Edwin I. Hatch Nuclear Plant
Response to Request for Additional Information:
Power Uprate Submittal

By letter dated January 13, 1995, Georgia Power Company (GPC) submitted a Technical Specifications amendment request for the Edwin I. Hatch Nuclear Plant - Units 1 and 2. The proposed amendment increases the authorized maximum power level for both units from the current limit of 2436 MWt to 2558 MWt. On February 22, 1995, the NRC Staff met with GPC representatives to discuss the proposed Technical Specifications revisions.

By letter dated March 10, 1995, the NRC requested GPC to provide additional information based on the January 13th submittal and data supplied in the February 22nd meeting. Enclosure 1 is GPC's response to the Request for Additional Information. Enclosure 2 provides information relative to Plant Hatch setpoint methodology and calculations as requested by the NRC.

**Edwin I. Hatch Nuclear Plant
Response to RFAI
Power Uprate Submittal**

Figures 19-1 through 19-4 provide the drywell pressure and temperature responses for Units 1 and 2. The long-term pool temperature response, applicable to both units, is plotted in Figure 19-5.

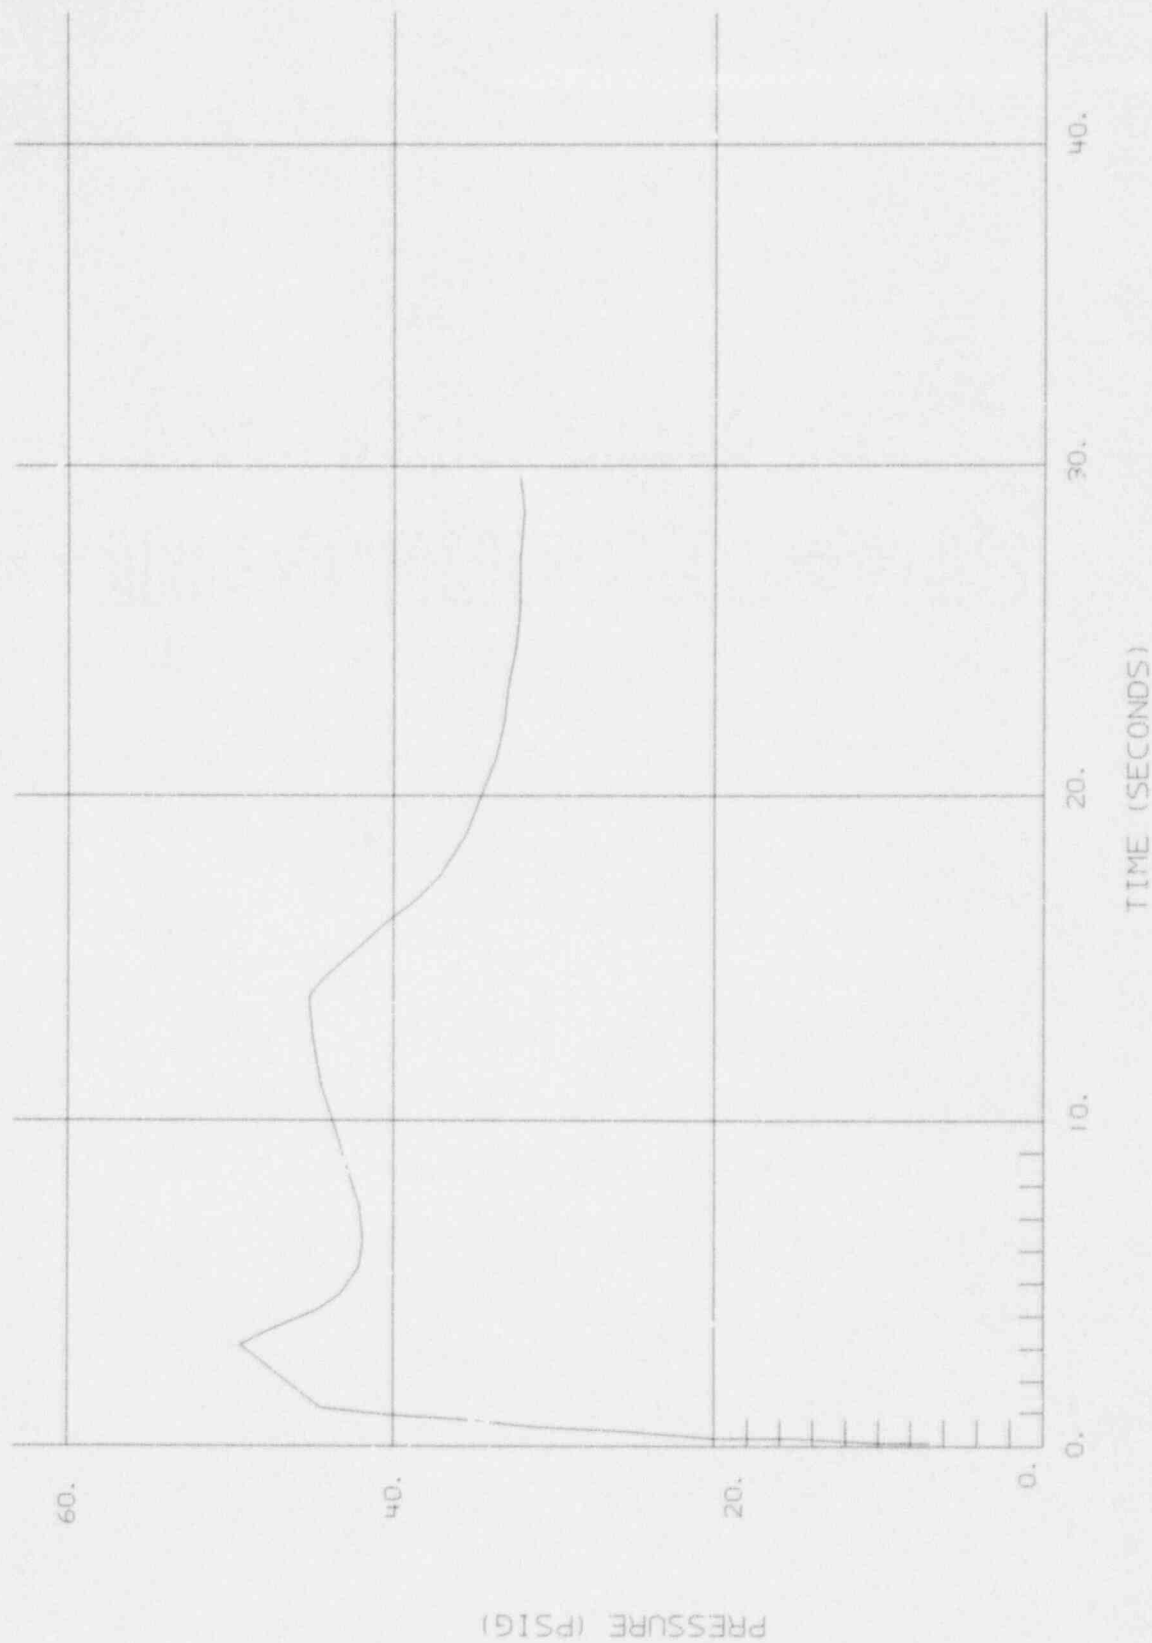
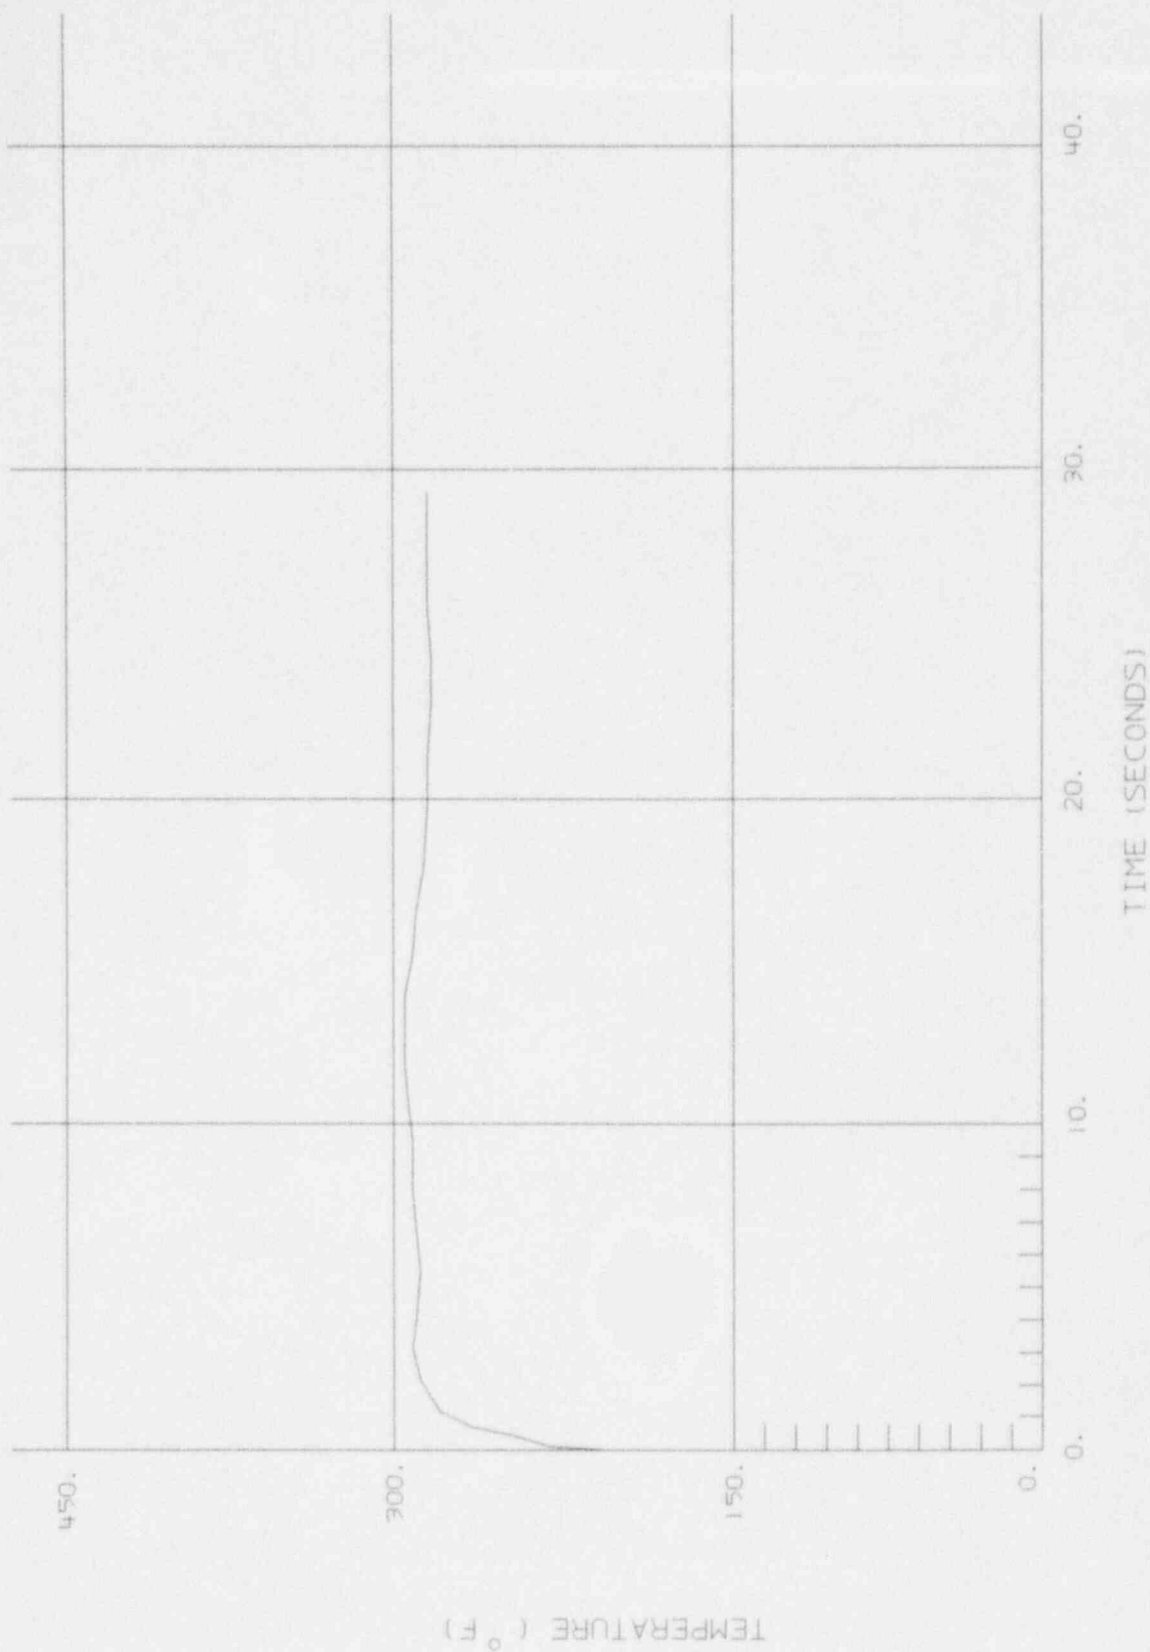
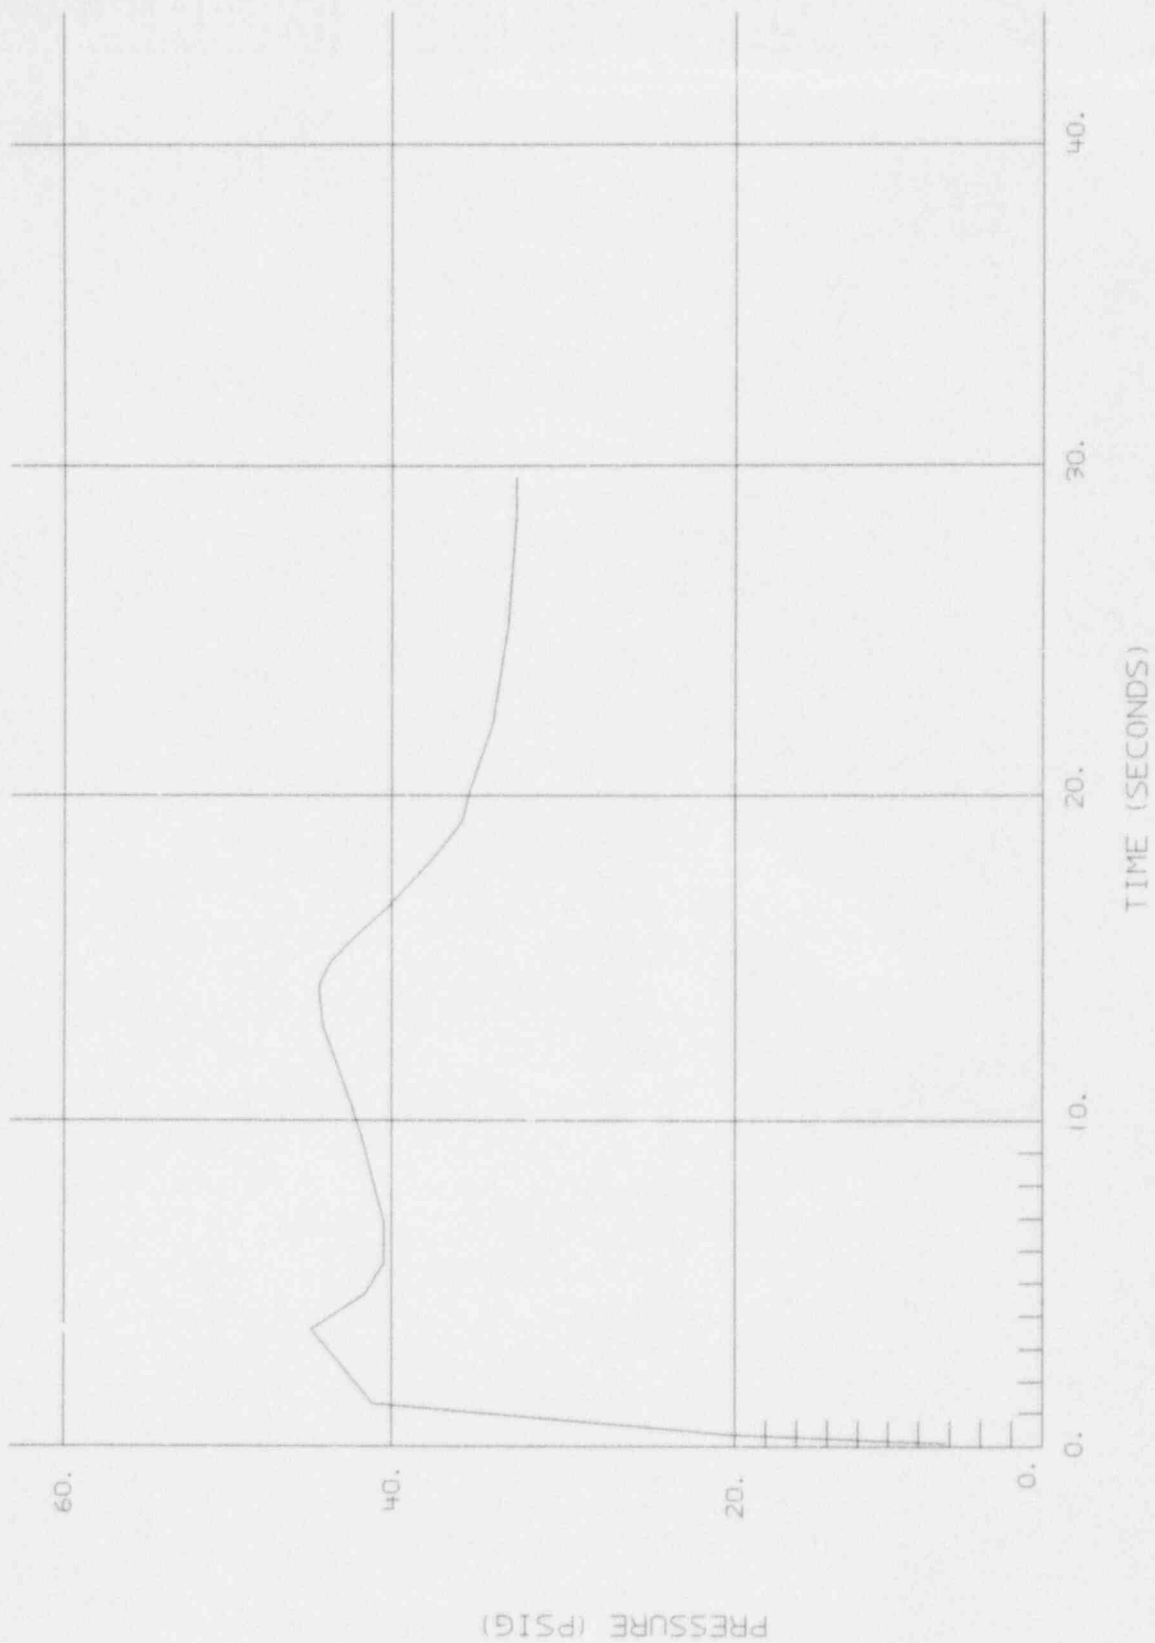
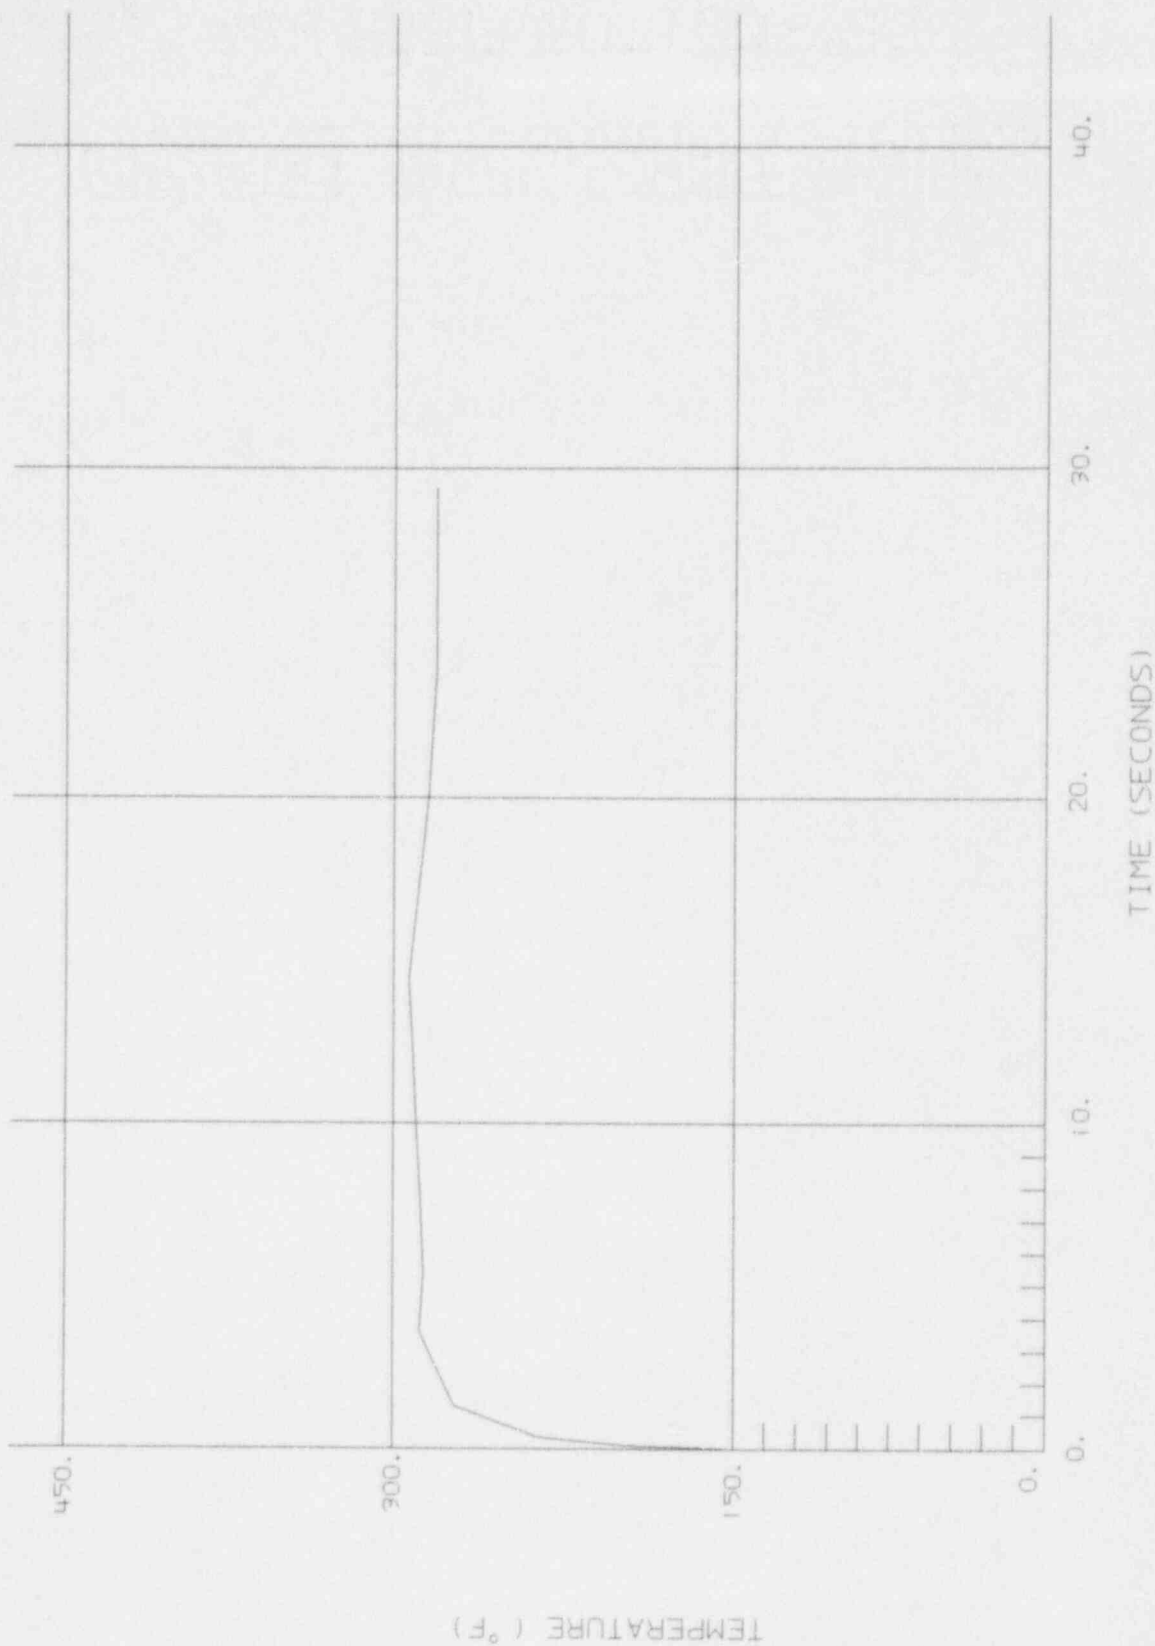
(Section 4.1.1) List the computer codes used for the containment pressure and temperature response. Provide figures showing temperature and pressure changes. Confirm that all other key input parameters except the decay heat codes are the same as in the current Final Safety Analysis Report. If not, provide details and discuss their effects on the pressure and temperature response.

Containment analyses are performed for both short-term and long-term response. Using the M3CPT computer code, short-term containment pressure and temperature response analyses were performed at various reactor operating points. These operating points included rated conditions (uprated power/rated flow) and off-rated conditions (extended load line limit [ELLL] and final feedwater temperature reduction [FFWTR]). For the rated point, the analysis method and input assumptions are identical to those used in the Mark I Long-Term Program (LTP). For off-rated points and the rated point, a detailed blowdown model (LAME) was used to calculate break flow rates and enthalpies. These LAMB break flow values were used as input to M3CPT (containment method used in the LTP). The reason for using LAMB flow values is that the blowdown model built in M3CPT is overly conservative at off-rated conditions. Relative to the long-term response evaluation, the SHEX computer code was used. No significant differences between SHEX and the previous analysis method were identified.

With regard to key input parameter differences (aside from the reactor power level and dome pressure associated with power uprate), the initial drywell temperature increased from 135°F to 150°F. The initial average drywell pressure increased to 1.75 psig, and the initial suppression pool temperature remained at 100°F. (The initial allowable pool temperature increased from 95°F to 100°F in 1988.) For the long-term temperature evaluation, the ANS/ANSI 5.1 decay heat model was used to calculate decay heat values as input to SHEX; whereas, the May-Witt decay heat model was most likely used in the previous analysis. The ANS 5.1 decay heat model is considered more realistic than the other model. In addition, the RHR flow rate is degraded 10 percent to 6900 gpm/pump, consistent with the degradation assumed in the existing SAFER/GESTR-LOCA analysis. All other key input parameters for the power uprate analysis are identical to those for the previous analysis.
